CORRECTIVE ACTION REPSONSE

DOCUMENT NUMBER: 696206065

FACILITY NAME: SR 698-21-01

Corrective action narrative from the 27-1 pit inspection on 31 July 2024:

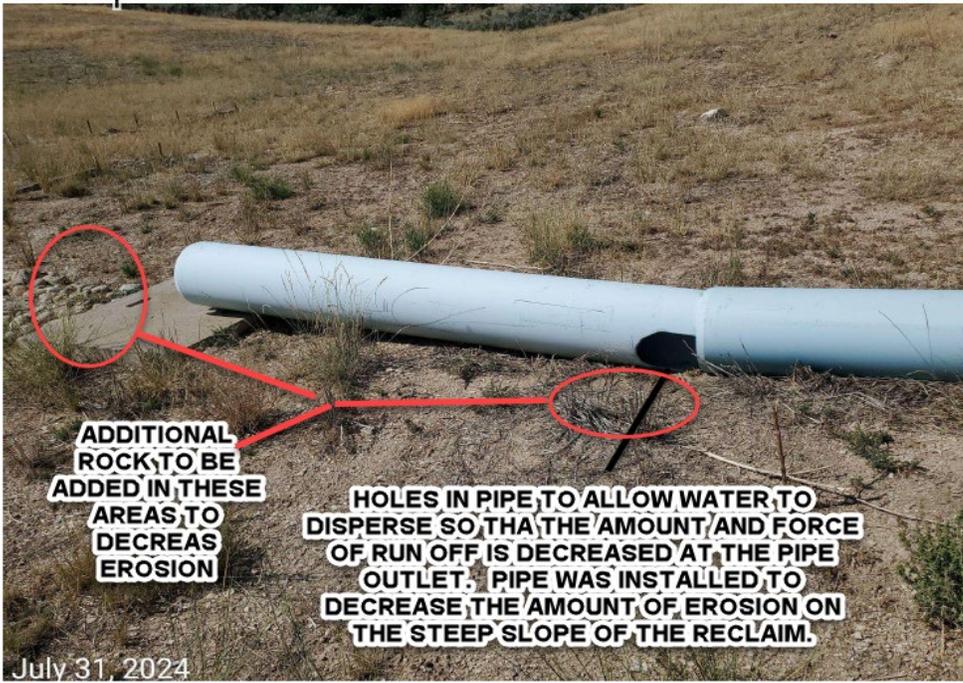
Operator has installed a slope drain from the access road; a section of the slope drain pipe has a crack/hole- hole will allow stormwater to divert into iintended areas of the reclamation where an engineered outlet has not been constructed. There are sections of erosion logs that are in disrepair; Erosion logs implemented appear to be constructed with non-biodegradable plastic. Silt Fence also observed to be in disrepair. BMPs that cannot be repaired will require proper disposal

New wattle fence has been installed and updated as needed. Wattle fence has been installed to reinforce existing straw wattles. The use of wattle fence was included in the Skinner Ridge 2023 SWAMP.

Wattles that are non-functional have been removed.

Rock apron has been installed at openings on pipe drain from culvert. The holes or openings on the pipe are there to decrease the amount of run off at the end of the pipe. The holes are to reduce the amount of and force of water at the outlet of the pipe. The holes also allow for distribution of run off and reduces the amount of run off at the pipe outlet.

**ADDITIONAL
ROCK TO BE
ADDED IN THESE
AREAS TO
DECREASE
EROSION**

**HOLES IN PIPE TO ALLOW WATER TO
DISPERSE SO THAT THE AMOUNT AND FORCE
OF RUN OFF IS DECREASED AT THE PIPE
OUTLET. PIPE WAS INSTALLED TO
DECREASE THE AMOUNT OF EROSION ON
THE STEEP SLOPE OF THE RECLAIM.**

**ROCK IN PLACE TO SLOW AND
DISSIPATE RUN OFF**

**ROCK IN PLACE TO DISPERSE
AND SLOW RUN-OFF WATER
FROM PIPE.**

**ROCK IN PLACE TO REDUCE VELOCITY
OF RUN OFF**
